August 28, 1995

SUBJECT: LaSalle County Nuclear Power Station Units 1 and 2
Application for Amendment of Facility Operating Licenses
NPF-11 and NPF-18, Appendix A, Technical
Specifications, and Exemption to Appendix J of 10CFR50
Regarding Elimination of MSIV Leakage Control System
and Increased MSIV Leakage Limits
NRC Docket Nos. 50-373 and 50-374

DESCRIPTION AND SAFETY ANALYSIS OF PROPOSED CHANGES TO APPENDIX A, TECHNICAL SPECIFICATIONS OF FACILITY OPERATING LICENSES NPF-11 and NPF-18

FIGURE 1

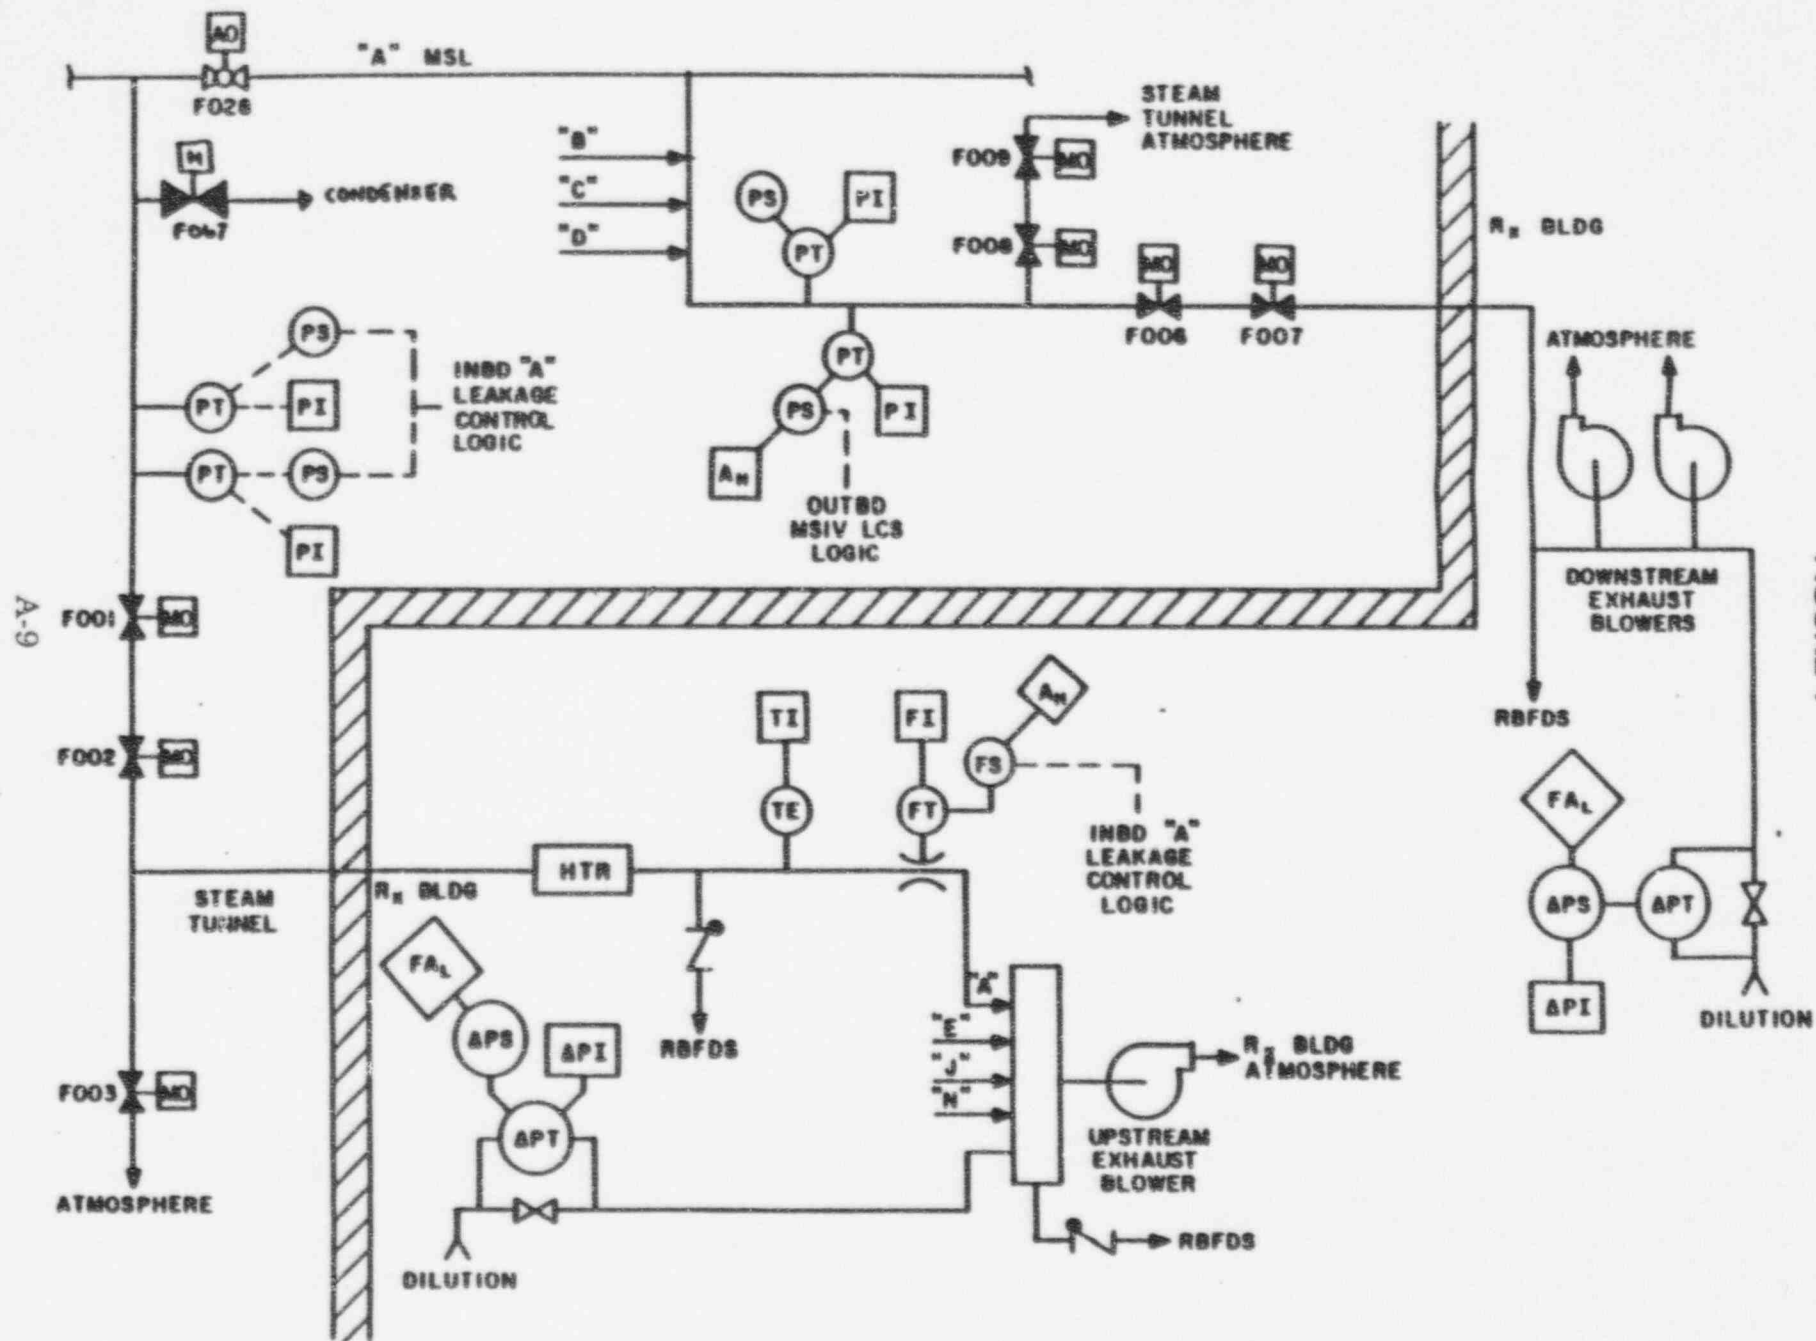
The MSIV LCS provides an alternate flowpath for MSIV leakage to secondary containment, where it can be treated by the Standby Gas Treatment system and released in a controlled manner through the stack. A diagram of the LCS at LaSalle is shown in Figure 1.

With the deletion of the MSIV LCS, which involves cutting and capping all piping connecting the MSIV LCS to the Main Steam system, MSIV leakage will pass from the outboard MSIV, through the Main Steamlines, Main Steamline Drains and into the condenser. The large volume in the main condenser holds up fission products that escape through the MSIVs, limiting release to the environment. This alternate pathway is more reliable than the existing LCS since less equipment is employed. The alternate pathway also has a much higher capacity for processing leakage than does the MSIV LCS, with a capacity of only 100 scfh. In addition, the MSIV LCS will only operate at less than 35 psig reactor vessel steam dome pressure, whereas the alternate pathway is independent of reactor pressure.

Due to the limitations and costs described above, ComEd proposes to replace the use of the MSIV LCS for processing MSIV leakage with the main steamlines, main steamline drains, and the main condenser. Diagrams of these systems, as well as an overall diagram of the revised flowpath, are found in Attachments H and I. Because this arrangement provides a higher capacity for processing leakage than the existing LCS, this request would also change the allowable MSIV leakage from 100 scfh for all four main steam lines to 100 scfh per steam line (400 scfh for all four main steam lines).
